Emergency Product Change Notification

Replacement of Monolithic windows for CBT-90-UV

June 12, 2018

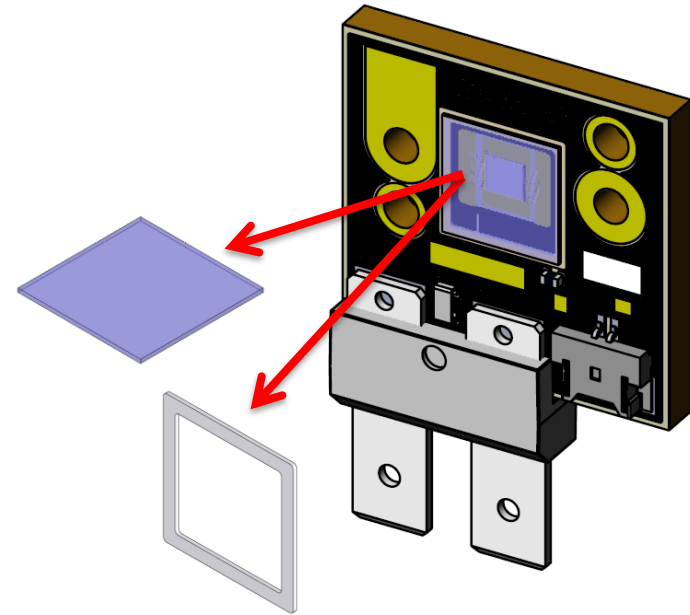
- Scope: the emergency PCN is applicable to certain UV products in production assembled using a monolithic “frame + window” component as described in the next slide.
- Proposed Change: Luminus is proposing to replace this monolithic component by discrete “Frame” + “Window” components. The proposed solution has been qualified to use for new UV products and only results in minor changes to the products that should be transparent to customers. These are explained in this presentation.
- At the same time, a lower thermal resistance die-attach material will be used. This material, already in use with other CBT-90 products, will lower Rth (junction-board) from 0.8 ° C/W to 0.45 ° C/W thus improving performance and lifetime. Product performance or reliability will not be adversely affected in any manner.

- Glass Vendor: same
- Window glass material: same
- Window glass thickness: same
- Window coating: same
- Transmission curve: same

No
optical
impact

Monolithic Window

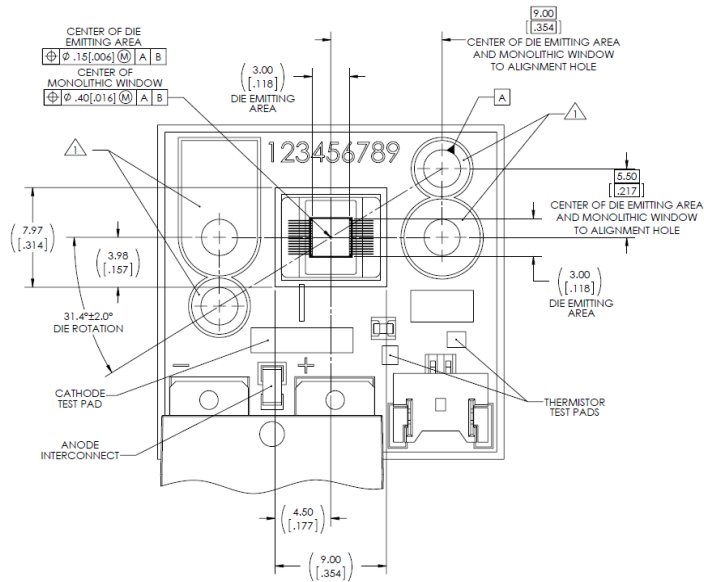
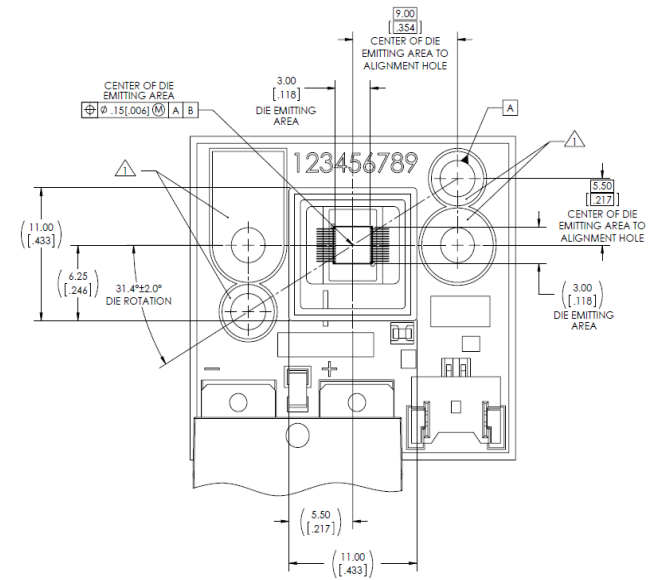
Dimension: 9.00m x 7.97mm

Dimension: 10.0m x 10.0mm

- Discrete window approach has minor differences in [XY] dimensional footprint
- Both options share same optical center placement with respect to datum
- Customers should confirm that this will not result in interference with surrounding tooling
- This is the only backwards compatibility concern with the discrete solution

Monolithic Window

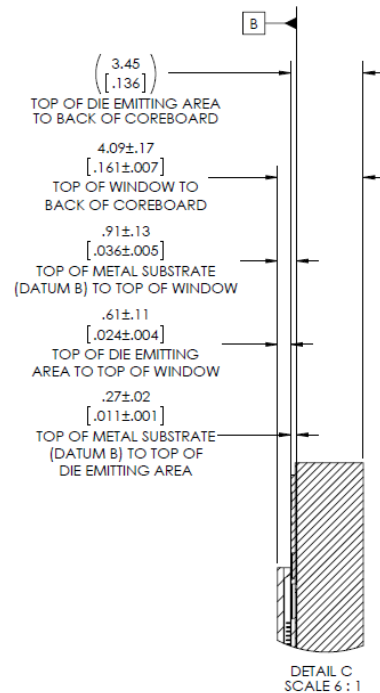
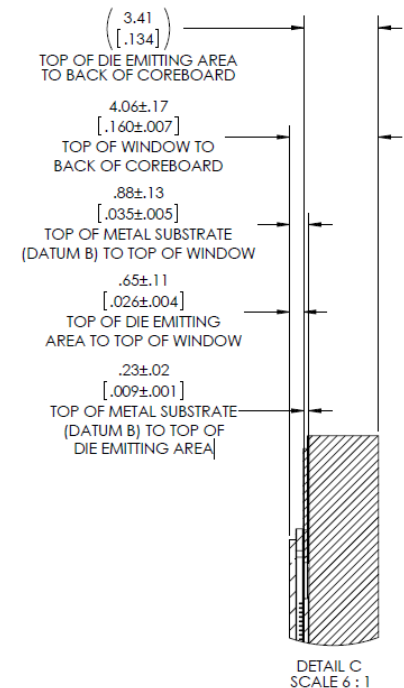
Top of die emitting area to top of window: *0.61 mm*

Top of window to back of coreboard: *4.09 mm*

Top of die emitting area to top of window: *0.65 mm*

Top of window to back of coreboard : *4.06 mm*

- Equivalent “Z-stack”: Window of Discrete option lower, ensuring no interference with surrounding tooling/optics
- As explained in slide 3, window element is identical for both approaches [thickness, material, AR coating] and made from same source glass sheets from same vendor.
